From: Sue Isherwood <sueisherwood9@gmail.com>
Sent: 11 April 2025 12:06
To: Amelia Elve <amelia.elve@somerset.gov.uk>; Jon Fellingham
<jon.fellingham@somerset.gov.uk>
Cc: 'Ros Wyke' <roswyke@yahoo.co.uk>; Chris and Ann Langdon
<chrislangdon@btinternet.com>; Rachel Spiller <clerk@westburysubmendip-
pc.gov.uk>
Subject: Westbury -sub-Mendip PC- submission concerning safe crossnig of the A371

Exploring potential for a safe pedestrian crossing of the A371 to meet requirements of WM1

Current outline application 2025/0137/OUT submission does not fully consider sufficient options for provision of a safe pedestrian crossing of the A371.

Fig 1 – showing approx sight lines for “stopping sight distances” by speed

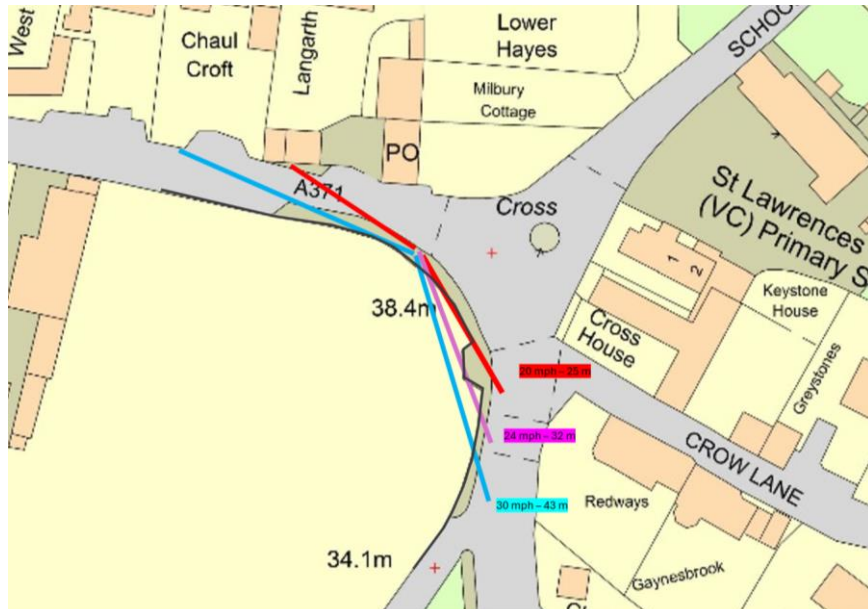
Does not offer sufficient sight line visibility looking south towards Station Rd (Wells) nor provides sufficient pavement width for poles for lights / signage. We believe the sight line visibility looking east towards cheddar is already satisfactory.

See fig 1 for sight line estimation for 20 mpg; current 85 percentile speeds of 24 mph and for current speed limit of 30 mph (extracted from manual for streets)

Sight Line requirements (looking south). Sight lines require that additional land is available to provide unrestricted view of traffic / pedestrian crossing point for distances to suit assumed traffic speeds. This would require any obstacles (walls and railings) to be under 600mm along the sight line visibility splay. Either from reduced height of current wall or relocation of wall behind a sight line visibility splay.

The working assumption proposed is that a 30 mph sight line is not necessary given existing traffic speed (85%) are 24mph (Pell Frischmann Traffic Survey) but that sight lines for 20 mph assume too much - successful implementation of this speed limit – and that this reduces speeds to 20 mph or below. Proposal therefore works on sight lines necessary for 24 mph speeds

Fig 2 – Route of existing public footpath across Court House Farm garden

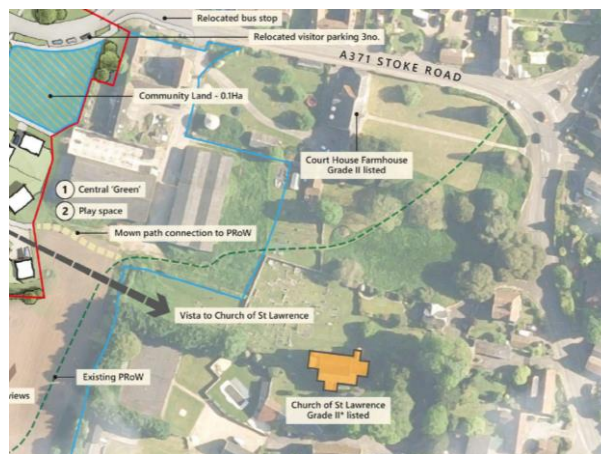
Land availability: The owners of Court House Farm have indicated they are open to being part of a solution if making available a slice of land would solve sight line and pavement width issues. They would require that the existing footpath across the front garden is diverted such that it does not cross part of the property. See Fig 2.

Footpath Diversion – There are a number of possible routes that a diverted footpath might take – either west along A371 and then south through proposed new RL access or south to land surrounding church and then west. The route that perhaps would make most sense from (line of desire) would be west along the A371. This alternative route was in use for many years prior to 2012 (?). Footpath diversion assessment required (and pavement widths addressed).
